Town of Simsbury

To: Simsbury Zoning Board of Appeals

From: Joseph Hollis, Code Compliance Officer

RE: **Application ZBA #24-01** of Raising Cane’s Restaurant, LLC, Applicant, Simsbury Commons, LLC, Owner; for variances to Section 9.3 of the Simsbury Zoning Regulations for an additional ± 211 sq. ft. of signage and the use of internal illumination for such signage at Raising Cane’s Restaurant, 530 Bushy Hill Road (Assessor’s Map B20 Block 508 Lot 001-B), Simsbury, CT 06070, zone B-3.

Graphic 1 (Right): Proposed Sign Plan.

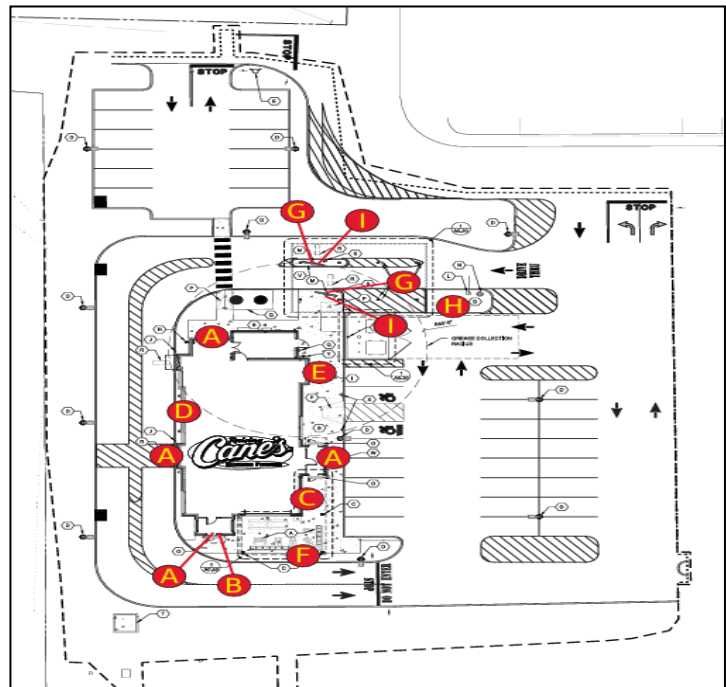
The applicant is proposing 11 signs on the site as outlined in Graphic 1. The proposed sign plan exceeds the limit allowed under the zoning regulations in the size of wall signage, freestanding signage, and the total signage allowed on the site.

The proposed sign plan exceeds the limit for freestanding signs by 33.57 SF, wall signs by 161.53 SF, and the total site signage allowance by 211.12 SF. The application also features the use of internal illumination for 2 menu boards, 1 pre-sell board, and the chicken fingers interior sign which is prohibited by the regulations to be discussed in the analysis section of this staff report.

Graphic 2 (Below): Two proposed displays. One Love Heart on the left. Red Dog on the right.

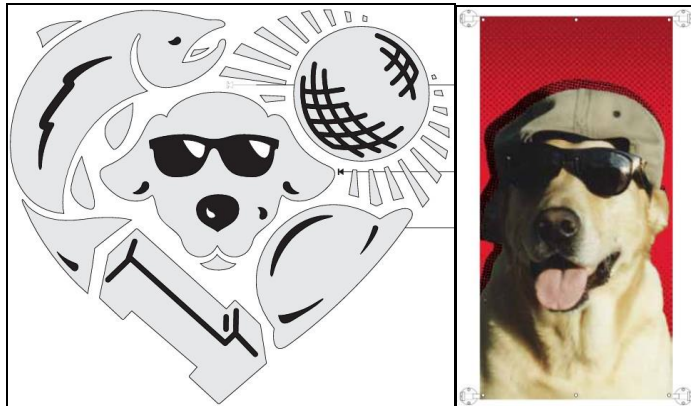
In the submitted application, the applicant identified two specific hardships in requesting the size and illumination variances. First, with regard to the One Love Heart and the Red Dog displays (shown in Graphic 2 below), “Both images of art displays...don not convey any word/text and are not traditional signs...so it is a hardship to restrict these images by the sign allowance.” Second, “the unique and remote area... of the building at the site creates a hardship with regard to visibility of signage from road view...”

The application also states the displays shown in Graphic 2 should be considered artwork and should not be included in the total proposed signage, but by doing so creates a hardship for the property. The two displays meet the definition of a sign as referenced in Section 17.4 and are included in the signage calculation. Had the two displays be excluded, the application would still be a variance request of ± 139.24 SF of signage over the allowed. The board should evaluate the elements of the case including the following criteria when making their determination on the application.
